Access Compliance Report

Public Rights-of-Way

(Curb Ramps)

Intersection ID: 27369	Main Street: JORDAN_RAE_LN	Cross Street: MEADOW_RUN_LN	Location: SE
ADA ID: C9263C44FE80	Ramp Type: BlendTrans2	Initial Pass/Fail: Fail	Overall Compliance: No
		Severity Score: 10

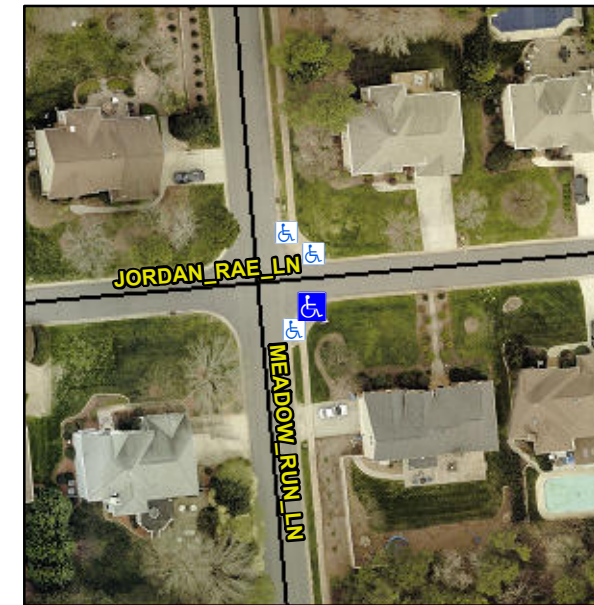
Not Found, R304.5.1, R304.5.3

Compliance	Description	Data	Compliance	Description	Data
N/A	Ramp Length (in)	94.0	Yes	BlendTrans Slope (%)	4.0
No	Ramp Width (in)	39.0	No	BlendTrans XSlope (%)	4.0
N/A	Flare Type LT	N/A	N/A	Flare Type RT	N/A
N/A	Flare Slope LT (%)	N/A	N/A	Flare Slope RT (%)	N/A
N/A	Flare Traversable LT?	N/A	N/A	Flare Traversable RT?	N/A
N/A	Landing Length (in)	N/A	N/A	DWS Provided?	N/A
N/A	Landing Width (in)	N/A	N/A	DWS Contrast?	N/A
N/A	Landing Slope (%)	N/A	N/A	DWS Length (in)	N/A
N/A	Landing X Slope (%)	N/A	N/A	DWS Full Width?	N/A
N/A	Landing Curb? (Y/N)	N/A	N/A	DWS Offset (in)	N/A
N/A	Shared Landing?	N/A			
N/A	Gutter Ponding?	N/A	N/A	Gutter Slope (%)	N/A
N/A	Gutter Lip Ht (in)	N/A	N/A	Gutter X Slope (%)	N/A
N/A	Painted X Walk1?	No	N/A	Painted X Walk2?	N/A
	X Walk 1 Direction	To N		X Walk 2 Direction	N/A
	X Walk 1 Width (in)	N/A		X Walk 2 Width (in)	N/A
	X Walk 1 Slope (%)	4.3		X Walk 2 Slope (%)	N/A
	X Walk 1 X Slope (%)	3.3		X Walk 2 X Slope (%)	N/A

N/A	Ramp inside XWalk1?	N/A	N/A	Ramp inside XWalk2?	N/A
	Road Slope (%)	3.3		Clear Space?	N/A
	Road X Slope (%)	4.3	N/A	Clear Space to XWalk (in)	N/A
N/A	Any Obstructions?	N/A	N/A	Storm Grate/Utility Hazard?	N/A
	Obstruction Type			Storm Grate/Utility Type	
		N/A			N/A
			Yes	Surface Condition? (G/P)	Good
			No	Curb Slope (%)	6.2

Remove & Replace Curb Ramp With Two New Directional Ramps or Equivalent.
